**(NEW) Q+A QUESTIONS + ANSWERS – Questions submitted through October 3, 2025**

### (PRIOR) Q+A QUESTIONS + ANSWERS – Questions submitted through September 26, 2025

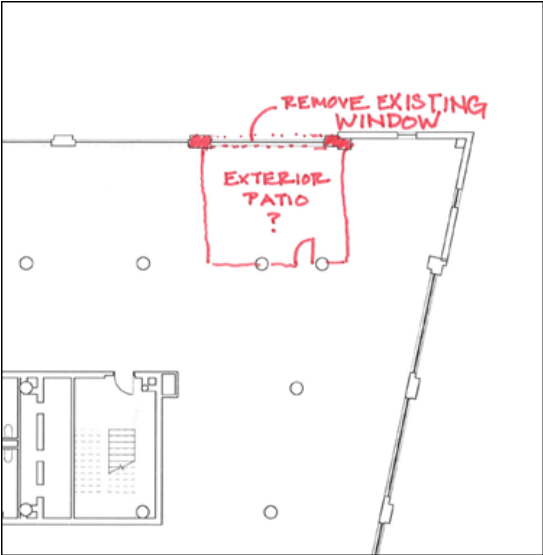
Q: It states 3 days in office as a part of the hybrid plan, and 4 days in office in another part of the brief. Please clarify.

**A: Our apologies on the discrepancy on page 7 and 27 and thank you for bringing this to our attention. Consider (four days) that is mentioned on page 27 to be the guidance for NEXT.**

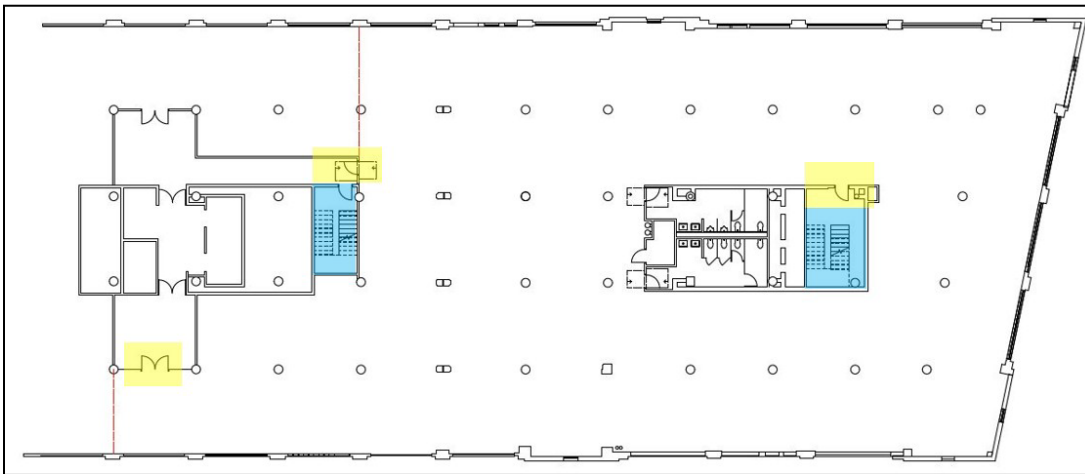
Q: Are all three of the doors (highlighted in yellow) considered a means of egress for exiting? Do the enclosed stairs (highlighted in blue) lead to an exit discharge on the main level?

**A: Yes, the yellow shaded areas are egress. Yes, the blue shaded lead to the main level.**

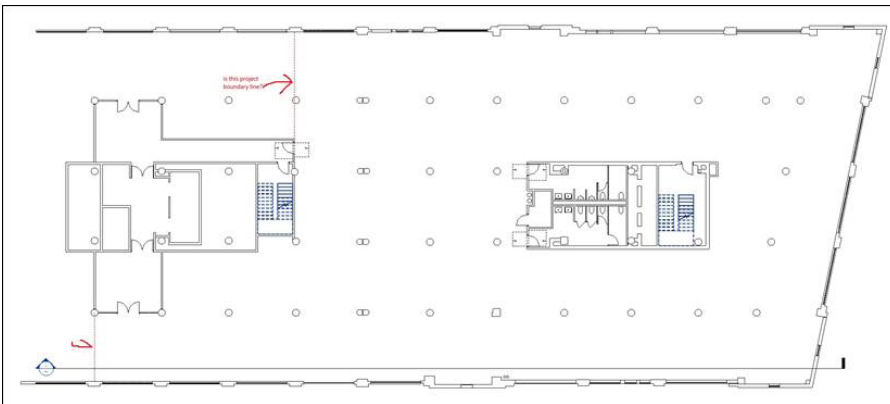
Q: Which door is considered to be the primary entrance to this level?

**A: The primary entrance is the one plan-south of the elevator lobby. This provides good elevator lobby exposure.**

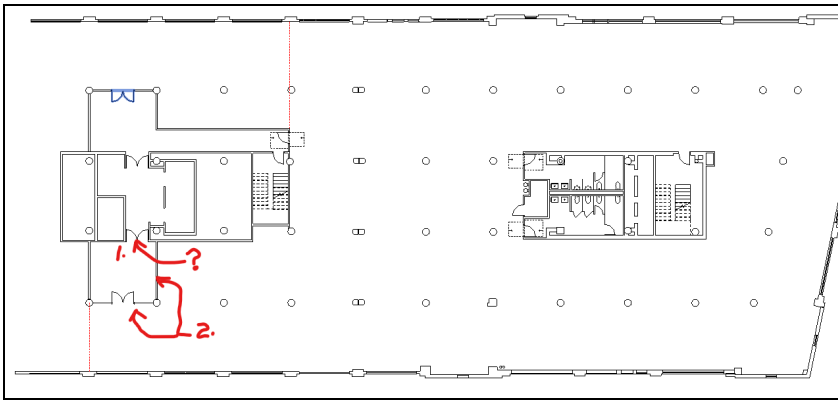
Q: Can students have the Steelcase architectural walls meet a window mullion or do all walls have to meet a wall?

**A: The preferred location is a wall or column; however, our walls come with “mini ends” with every product line to come off walls or mullions as standard. The reason being, very few walls are square and plumb, so the mini end expands and compresses to account for variations in the wall. It kind of acts like a shim, if you will, because our walls are always square, so it marries the two.**

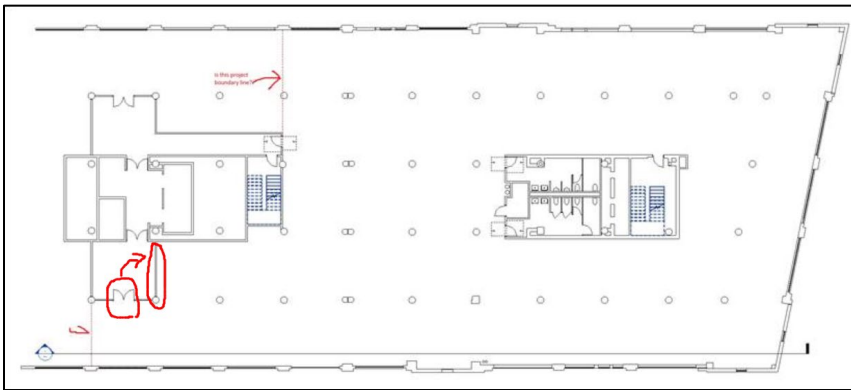
Q: Is the sub-lobby to the south of the elevator also considered part of the core space, or are students free to eliminate walls and doors south of those leading directly to the elevator lobby (door and walls #2)? I can hold this question until the official Q&A if it is not deemed appropriate at this time.

**A: Door #1 cannot be eliminated. Door and walls #2 may not be eliminated; however, if your students would like to take advantage of this space for branding (which can be removed if they leave as a tenant), that is permitted. The location of door #2 can be moved if the student researches local codes and requirements and verifies if moving the door meets the local codes.**

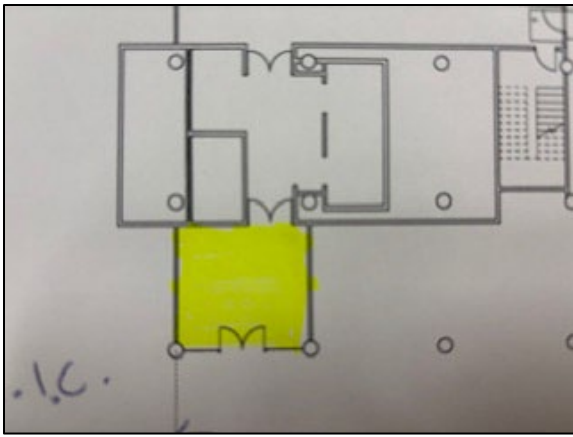
Q: Can we design the vestibule into the suite and use this square footage for furnishings or is this NIC? (see yellow in image below)

A: The vestibule should not be considered as part of the USF and is NIC. As mentioned on other Q+A shared in prior emails, the door location may be moved; however, not removed. If the student wishes to apply branding elements to the vertical surfaces of this area, that is permitted; however, furnishings should not be placed in this area.

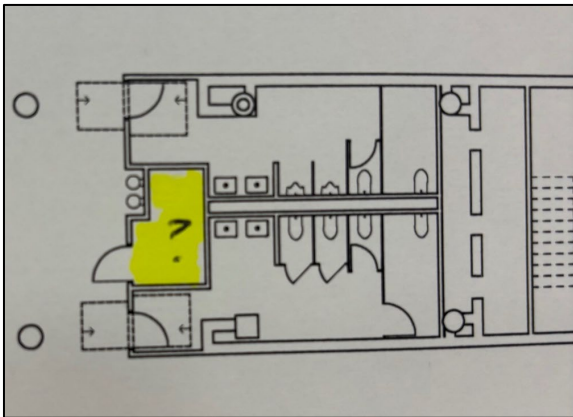
Q: What is the function of this room and can we use it or assume it's a janitor's closet, etc. and part of the NIC core?

A: Consider this to be part of the NIC (core building elements) and should not be considered as part of the design for the competition.
